SITE PLAN REVIEW AND APPEARANCE BOARD

File No.: 2019-235-SPI-SPR-CLI

Application Name: Delray Beach Plaza

The action before the Board is for the consideration of a Class I Site Plan modification for **Delray Beach Plaza** pursuant to LDR section 2.4.5 (F), including the architectural elevations.

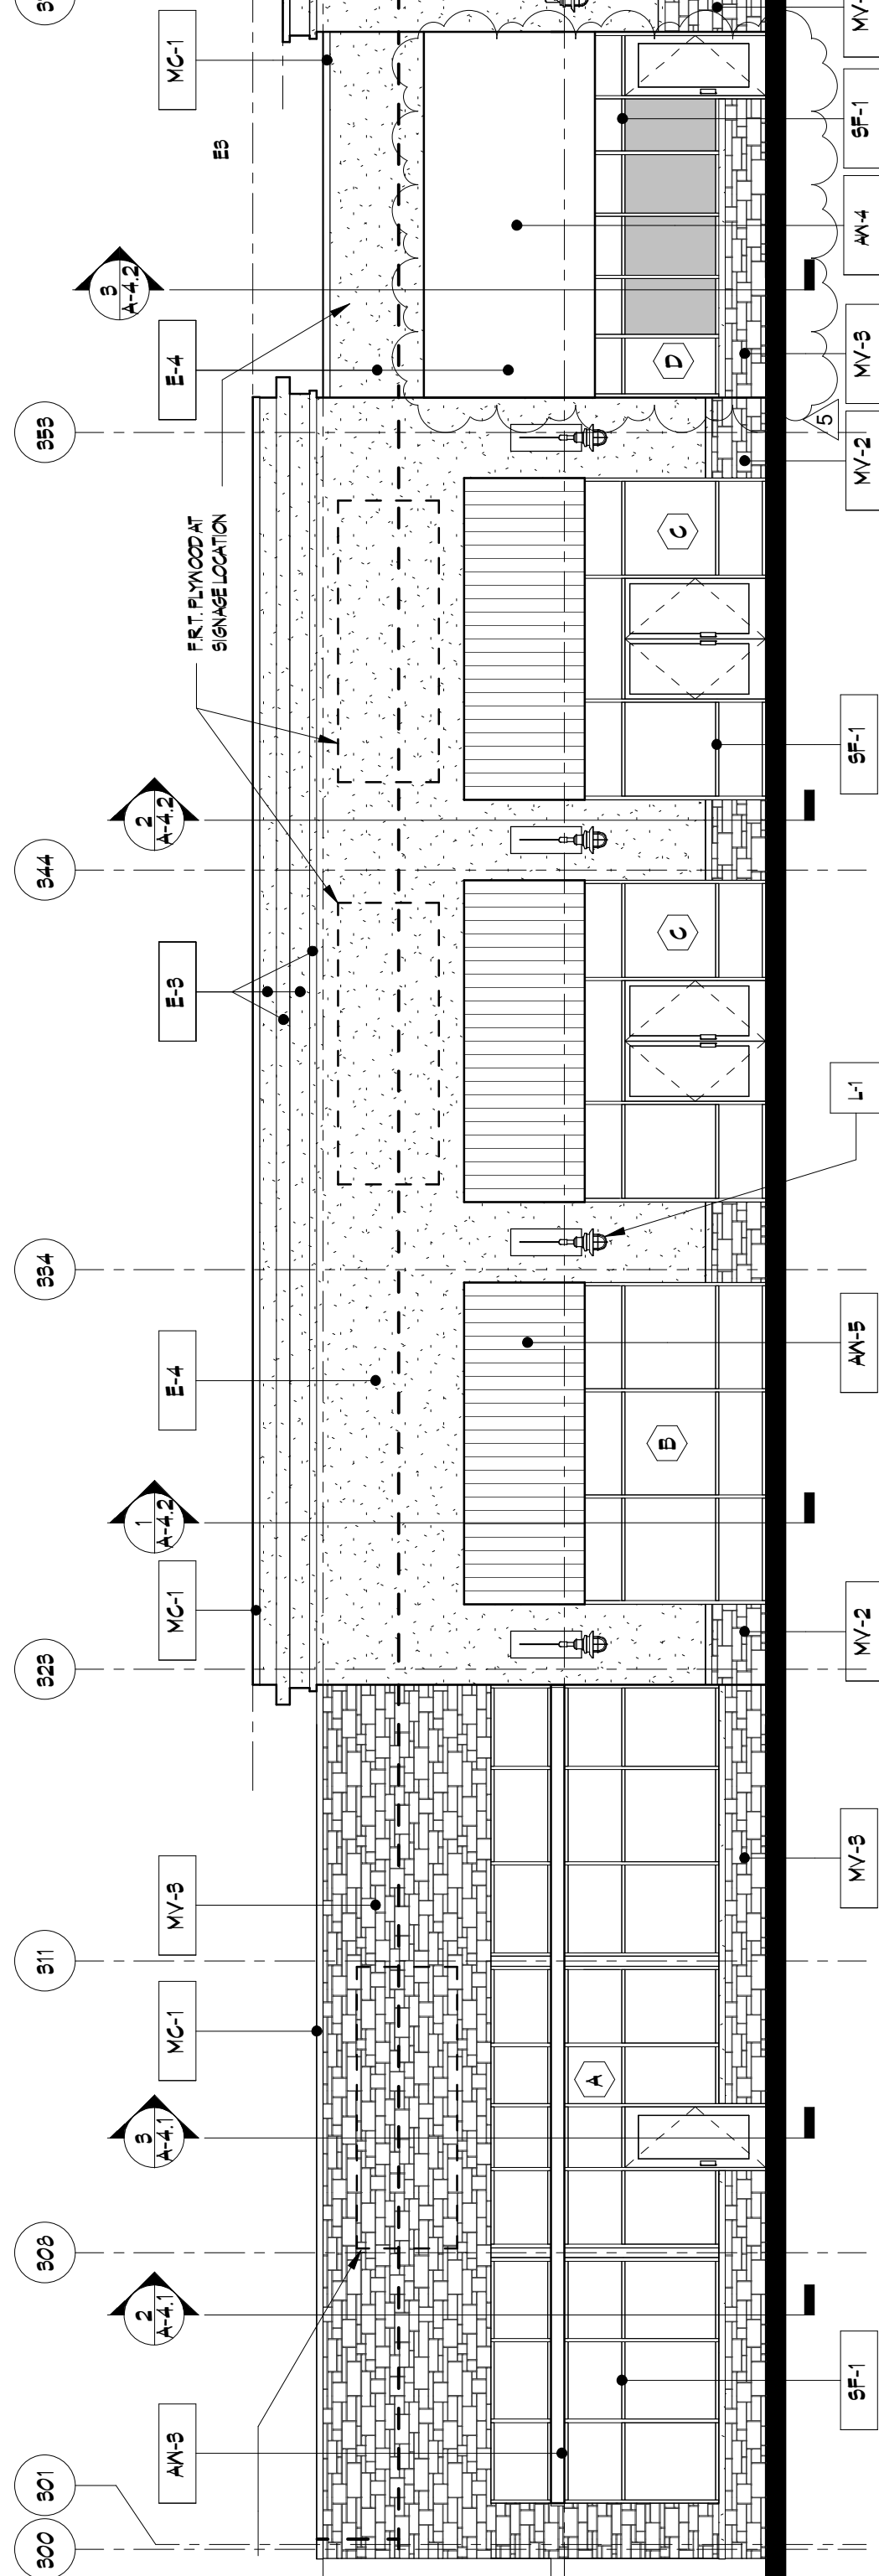
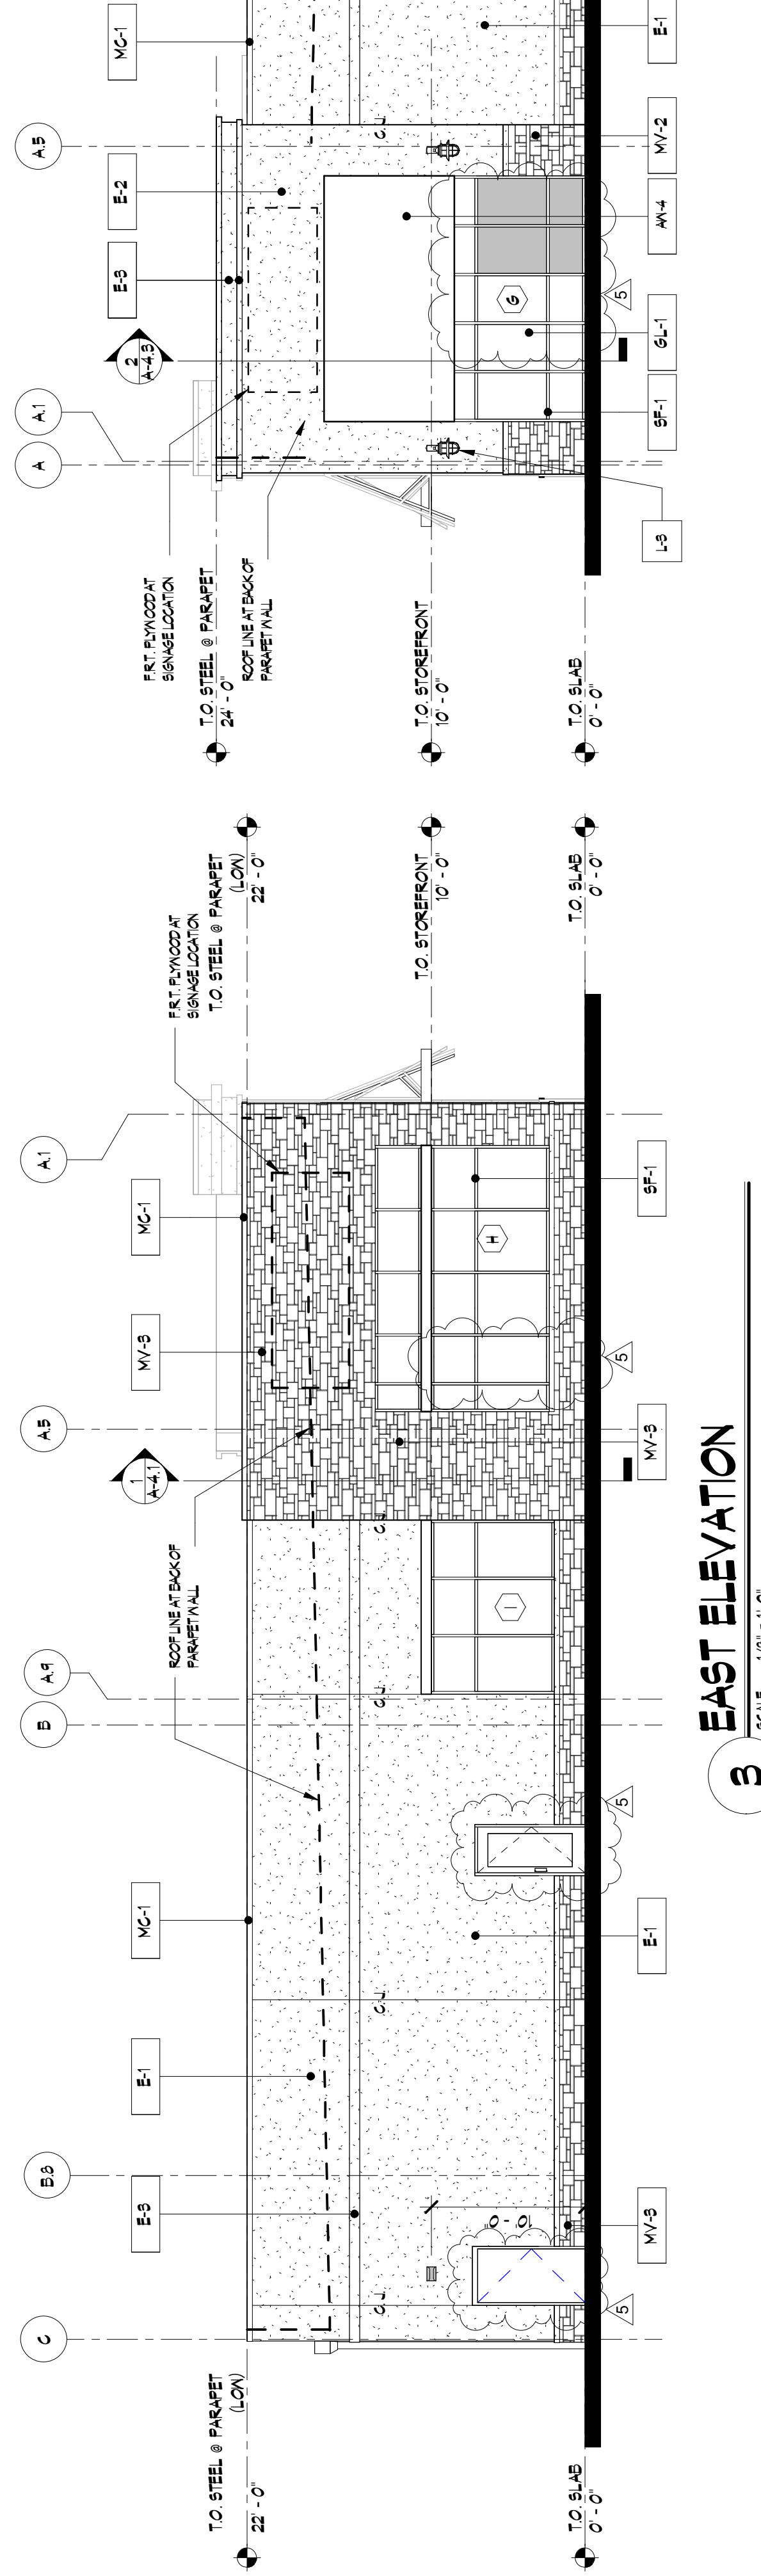
- As mentioned, the proposed site plans modification is associated with colors changes, an awning material change, and the minor relocations of windows and doors. The color changes consist of the change of wall color at the north west corner of the building from Sherwin Williams "White Tail" to "China Doll." Secondly, the awning color changed from orange to blue. In addition, the awning located above the second to last tenant space to the west changed from a flat metal awning to a "blue" canvas awning. Lastly, the proposed modifications to the window and doors included minor extensions of storefront glazing and the addition of four glass doors. The proposed changes are more compatible with the design of the remainder of the development which was previously approved by SPRAB in 2017. Thus, the proposed changes demonstrate good design practices to further City aesthetics.

1. Prior to building permit issuance, the revisions reflected in the Class I Site Plan (2019-235) modification shall be incorporated into the building permit set.
2. That color reference labels on page A3.1 and the colored elevations for building 300 be updated to reflect the correct proposed colors prior to site plan certification.
